THE HOMESTEAD RESORT

EXCEPTION TO STANDARD SPECIFICATIONS

APPLICANT'S PETITION

2025 SITE PLAN ALTERNATE (REVISED MAINTENANCE BUILDING)

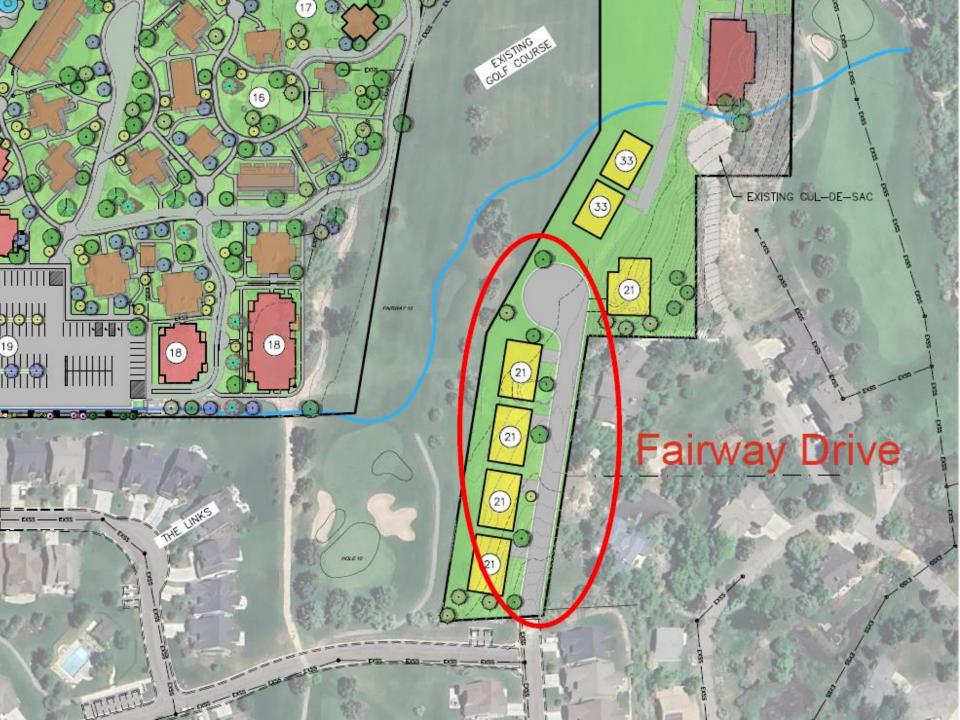
The neighbor, Lou Rodan, has landscaping on The Homestead side of the property line. The Homestead would like to accommodate the neighbor by preserving the existing trees and landscaping. This application is to reduce the road width from 26 feet to 20 feet and to increase the area next to the neighbor from 6 feet to 12 feet. This will help preserve the existing trees and landscaping and provide a larger buffer.

- The minimum fire code width is 20'.
- The diameter of the cul-de-sac will not change (90') and will comply with city and fire code minimums.
- The street is private and a cul-de-sac.
- The access easement with The Links and the approved master plan limit five dwellings to the cul-de-sac.
- The limited access will ensure a minimal number of trips per day on the cul-de-sac.
- No parking will need to be marked and enforced to maintain fire access if the road width is narrowed to 20'.
- Reducing road width will allow the mature landscaping to remain, which helps protect the existing structures from errant golf balls.
